Access Compliance Report

Public Rights-of-Way

(Curb Ramps)

Intersection ID: 14305	Main Street: CLEVELAND_AV	Cross Street: E WORTHINGTON AV	Location: E
ADA ID: BF470AB93B8B	Ramp Type: Directional1	Initial Pass/Fail: Fail	Overall Compliance: No
Severity Score: 1.25			
Codes/Mitigation Info/Possible Solution		Field Measurements/Component Compliance

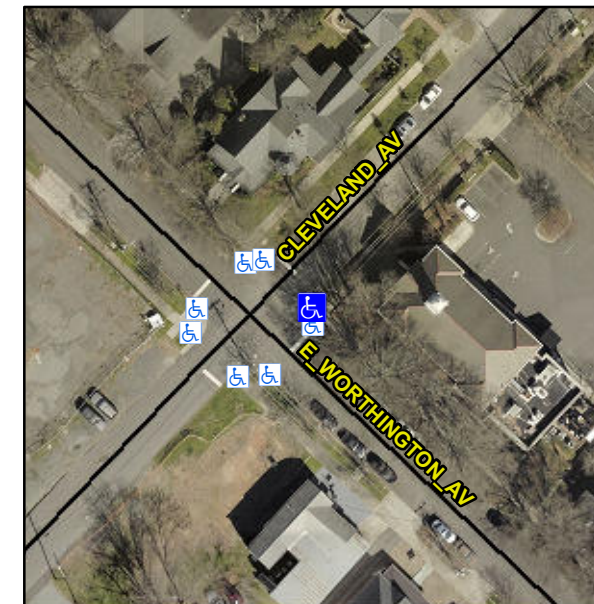
Compliance	Description	Data	Compliance	Description	Data
N/A	Ramp Length (in)	72.0	N/A	Grade Break?	N/A
Yes	Ramp Width (in)	60.0	N/A	Grade Break Slope (%)	0.0
Yes	Ramp Slope (%)	6.1	N/A	Grade Break XSlope (%)	0.0
No	Ramp XSlope (%)	4.4			
N/A	Flare Type LT	N/A	N/A	Flare Type RT	N/A
N/A	Flare Slope LT (%)	N/A	N/A	Flare Slope RT (%)	0.0
N/A	Flare Traversable LT?	N/A	N/A	Flare Traversable RT?	N/A
N/A	Landing Length (in)	0.0	N/A	DWS Provided?	N/A
N/A	Landing Width (in)	0.0	N/A	DWS Contrast?	N/A
N/A	Landing Slope (%)	0.0	N/A	DWS Length (in)	N/A
N/A	Landing X Slope (%)	0.0	N/A	DWS Full Width?	N/A
N/A	Landing Curb? (Y/N)	N/A	N/A	DWS Offset LT (in)	N/A
N/A	Shared Landing?	N/A	N/A	DWS Offset RT (in)	N/A
N/A	Gutter Ponding?	0.0	N/A	Gutter Slope (%)	N/A
N/A	Gutter Lip Ht (in)	0.0	N/A	Gutter X Slope (%)	N/A
N/A	Painted X Walk1?	No		Road Slope (%)	5.4
	X Walk 1 Direction	To NW		Road X Slope (%)	0.7
	X Walk 1 Width (in)	N/A		Clear Space?	N/A

X Walk 1 Slope (%)	5.4	N/A	Clear Space to XWalk (in)	N/A
	X Walk 1 X Slope (%)	0.7	N/A	Storm Grate/Utility Hazard?	N/A
N/A	Ramp inside XWalk1?	N/A		Storm Grate/Utility Type	
N/A	Any Obstructions?	N/A			N/A
	Obstruction Type		Yes	Surface Condition? (G/P)	Good
			N/A	Curb Slope (%)	6.7

Remove & Replace Entire Ramp.

R304.5.3
